Final Drainage Report
for
Rolling Hills Ranch North Filing 1
at
Meridian Ranch

PCD Project No. SF-2411

Rolling Hills Ranch North Filing 1 Final Drainage Report

Scale	1"=40'	Drawn by	TAK
Sheet Number	1	Checked by	-
		Date	JAN 2024

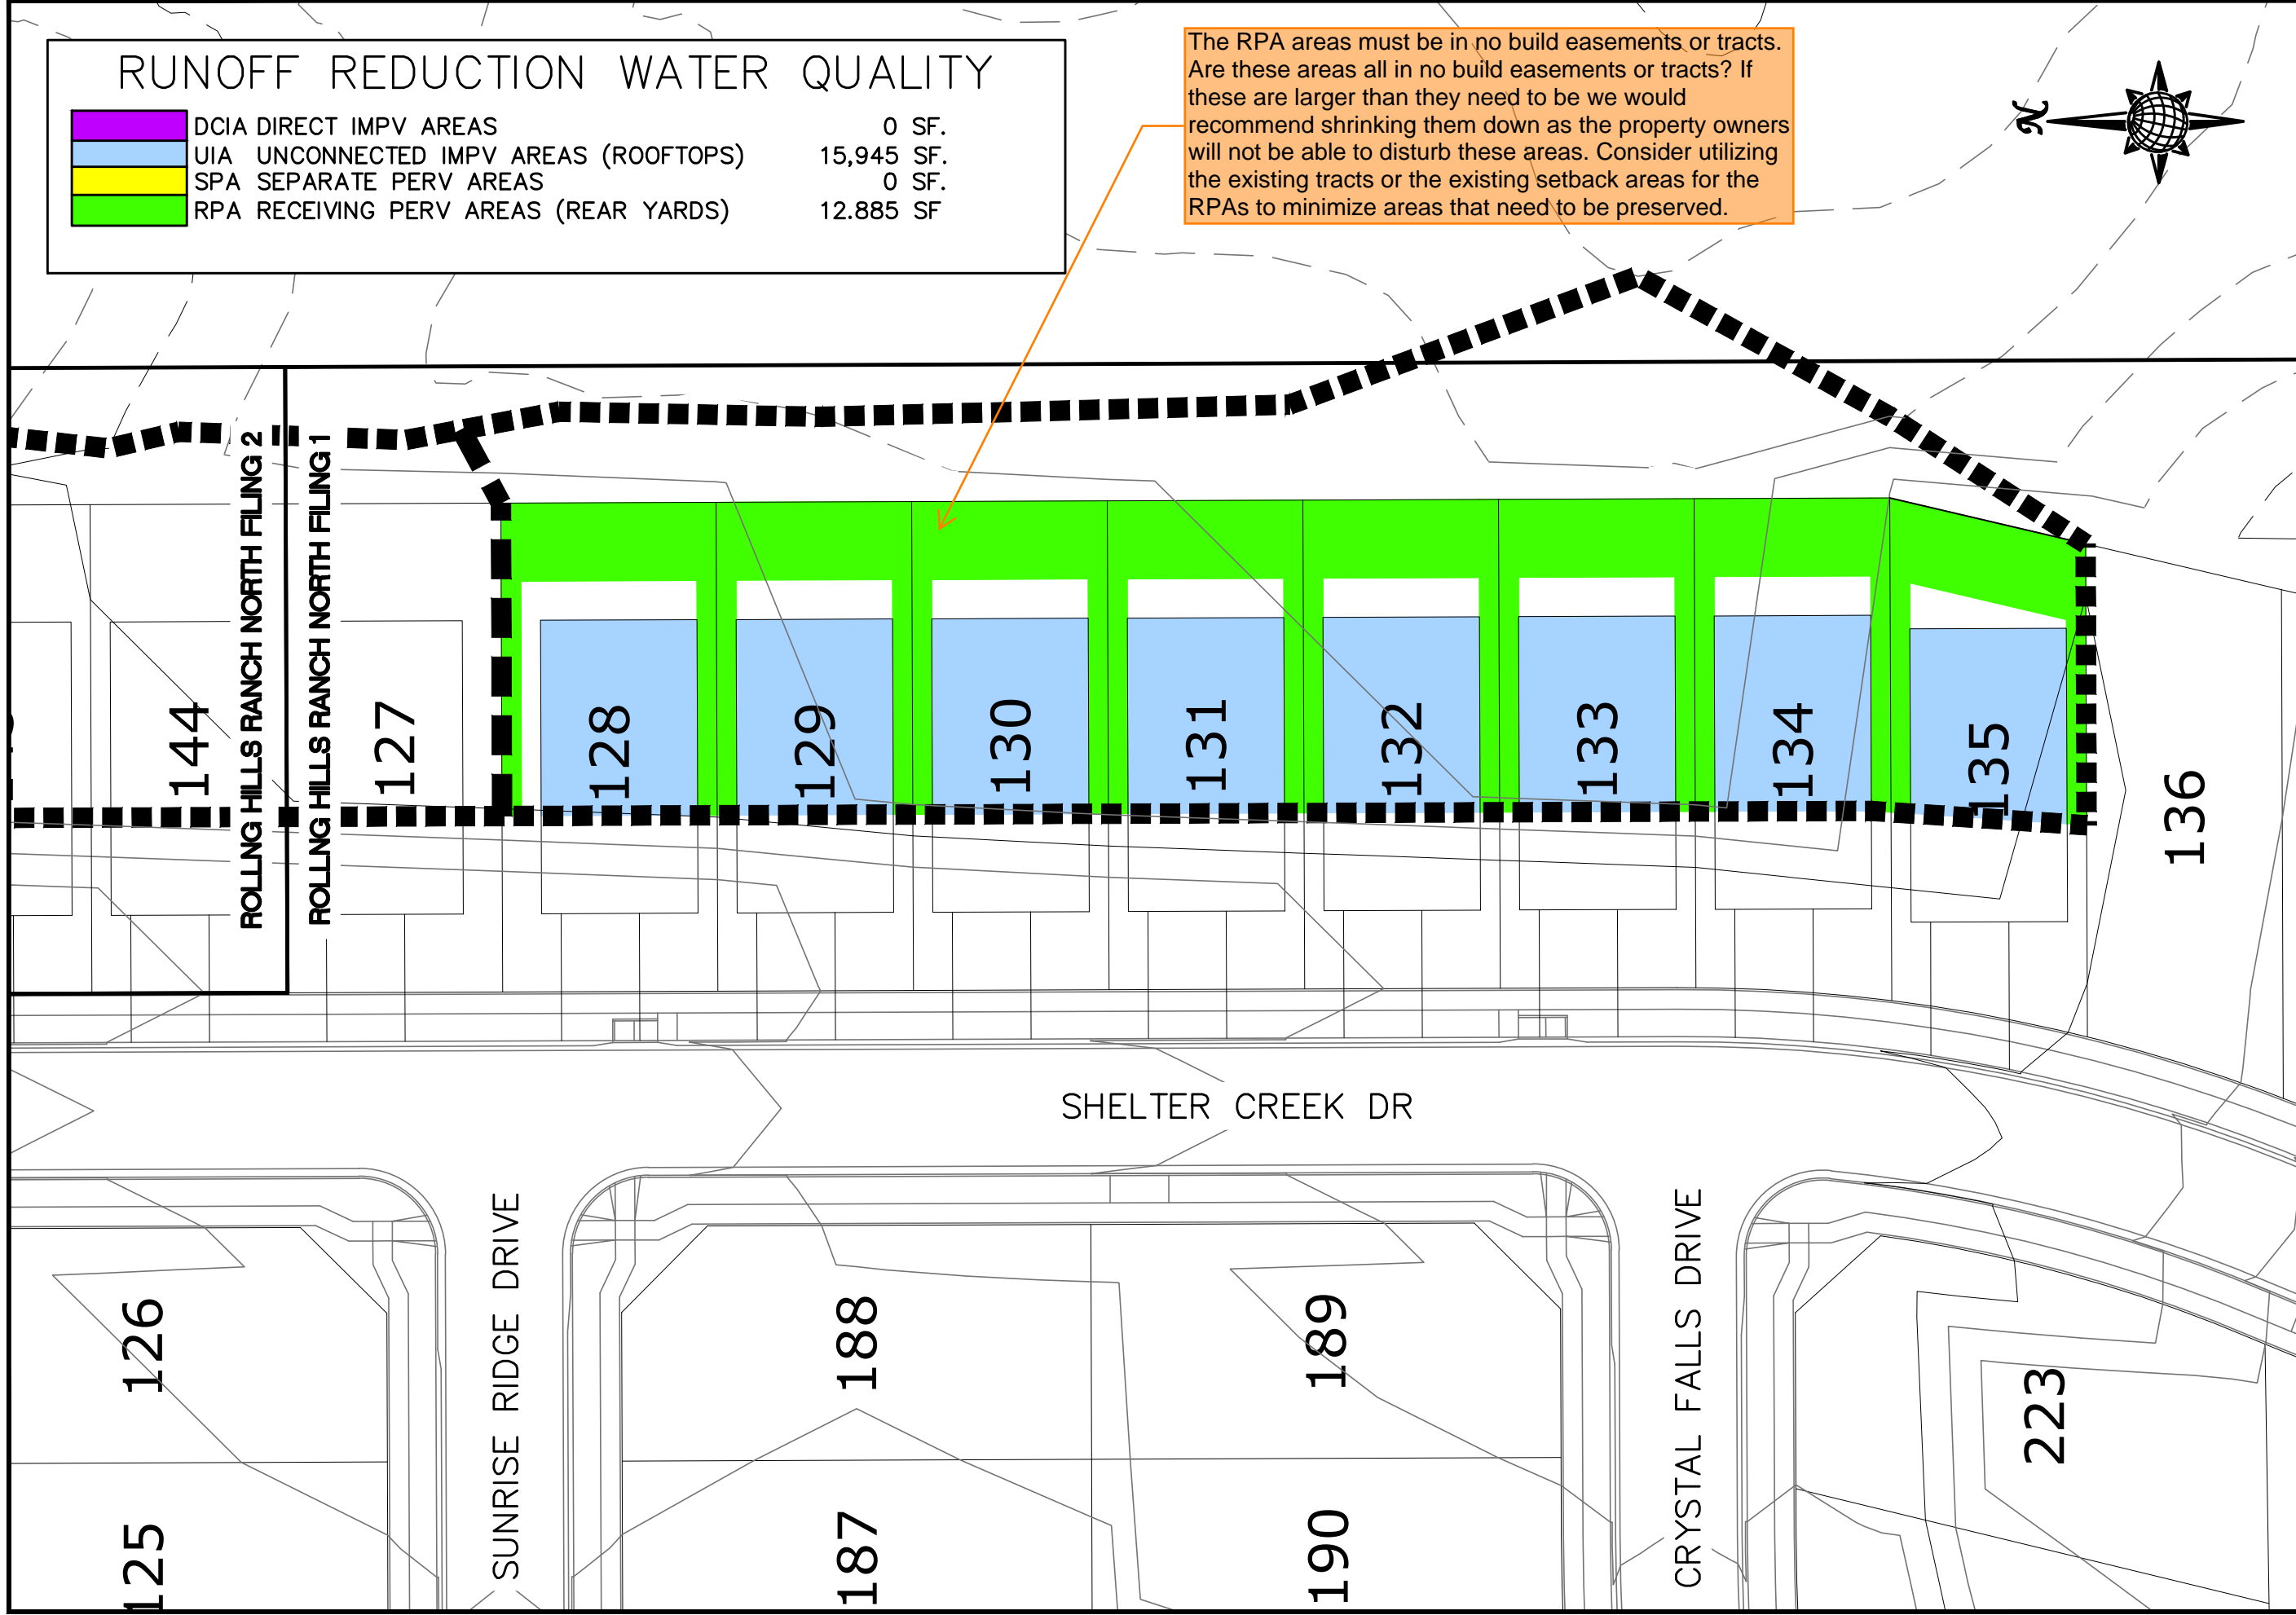
The RPA areas must be in no build easements or tracts. Are these areas all in no build easements or tracts? If these are larger than they need to be we would recommend shrinking them down as the property owners will not be able to disturb these areas. Consider utilizing the existing tracts or the existing setback areas for the RPAs to minimize areas that need to be preserved.

Scale	1"=40'	Drawn by	TAK
Sheet Number	2	Checked by	-
		Date	JAN 2024

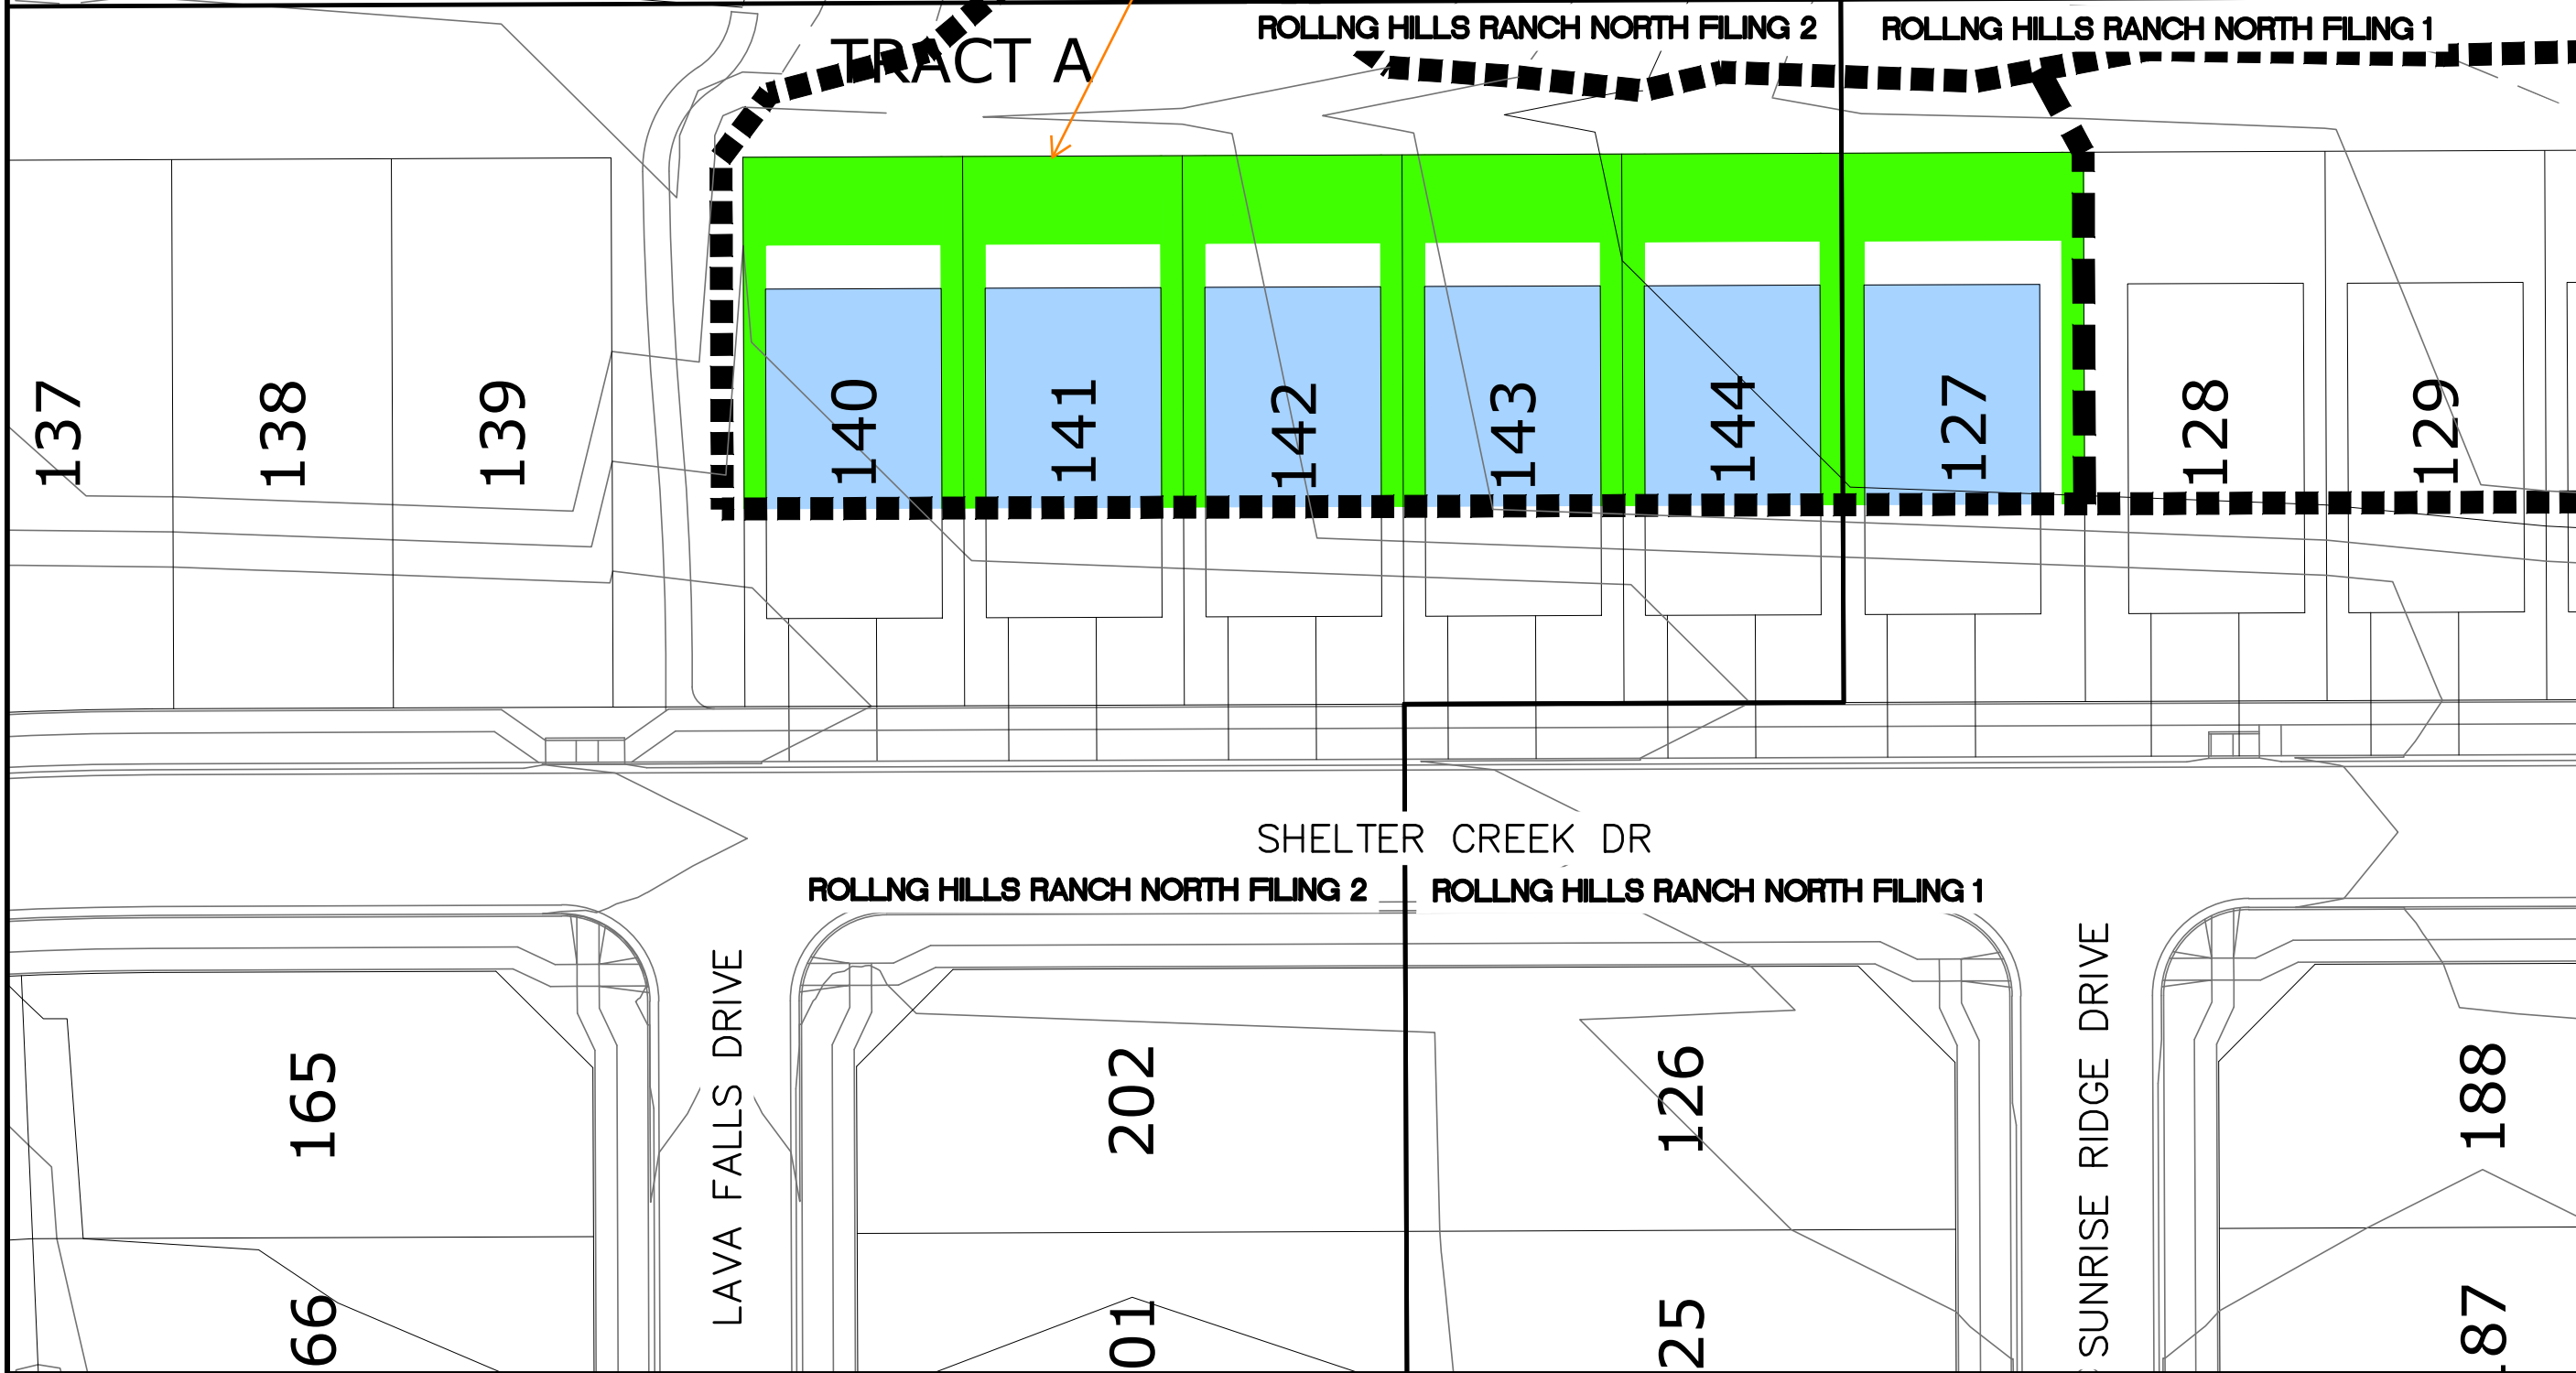
The RPA areas must be in no build easements or tracts. Are these areas all in no build easements or tracts? If these are larger than they need to be we would recommend shrinking them down as the property owners will not be able to disturb these areas. Consider utilizing the existing tracts or the existing setback areas for the RPAs to minimize areas that need to be preserved.
